Comments from the Chief Engineer/Mainland North, Drainage Services Department:

Project:
Temporary Animal Boarding Establishment for a Period of 5 Years and Filling of Land at Lot 1022 RP (Part) in D.D. 109, Kam Tin North, Yuen Long

(Application No.:A/YL-KTN/968)

Drainage Proposal - LAYOUT

D01

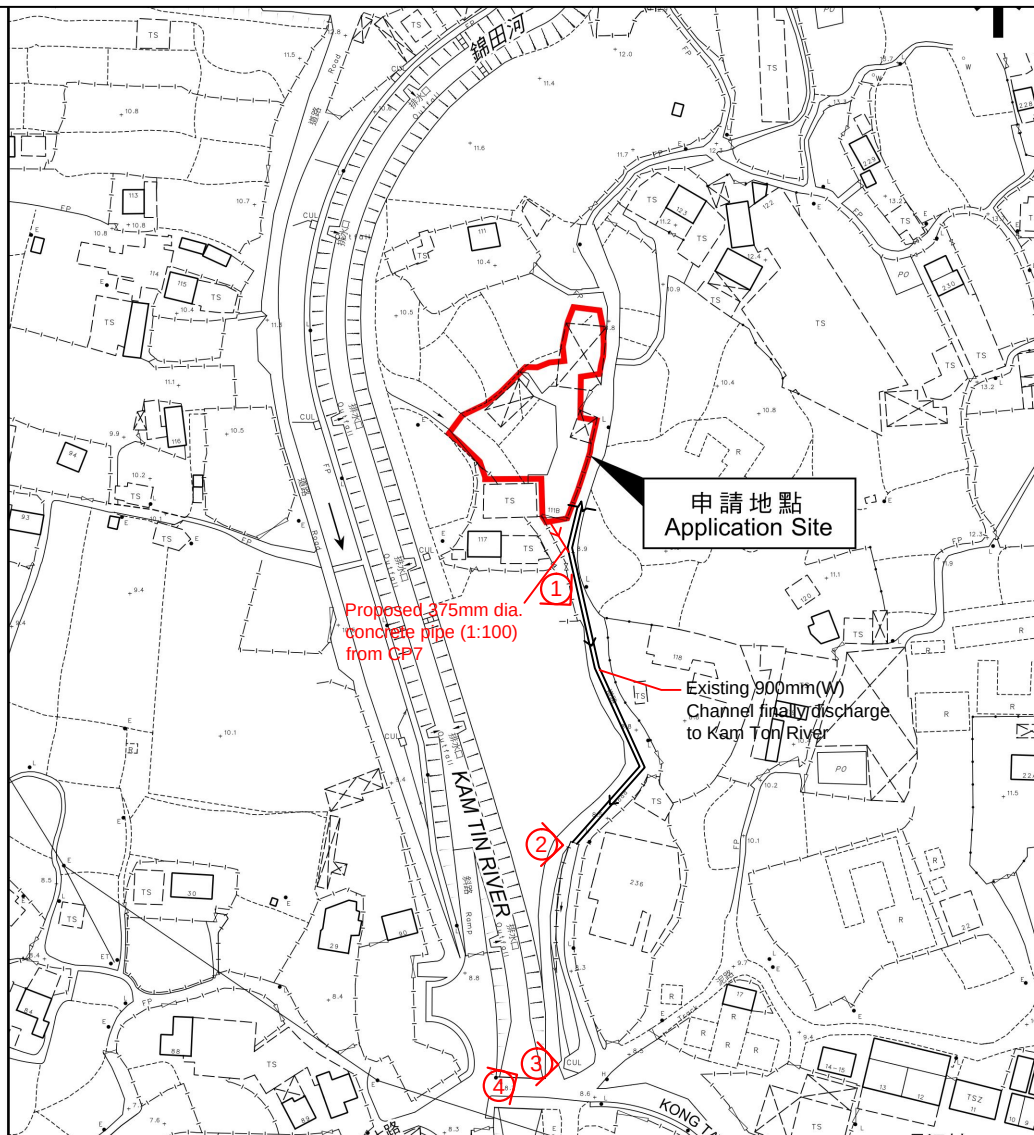
Drawings (No.: D01, D03 and D04): The applicant should clarify discrepancy of site formation levels shown on the submitted drawings and review cover levels of the proposed drainage facilities. Also, the applicant should update cross sections to reflect existing and the proposed ground profile of application site and its adjacent areas. Proper surface channels should be provided at the lower platform and wall toe to collect the overland flow to/ from adjacent areas.

D01, D03 and D04 are revised accordingly.
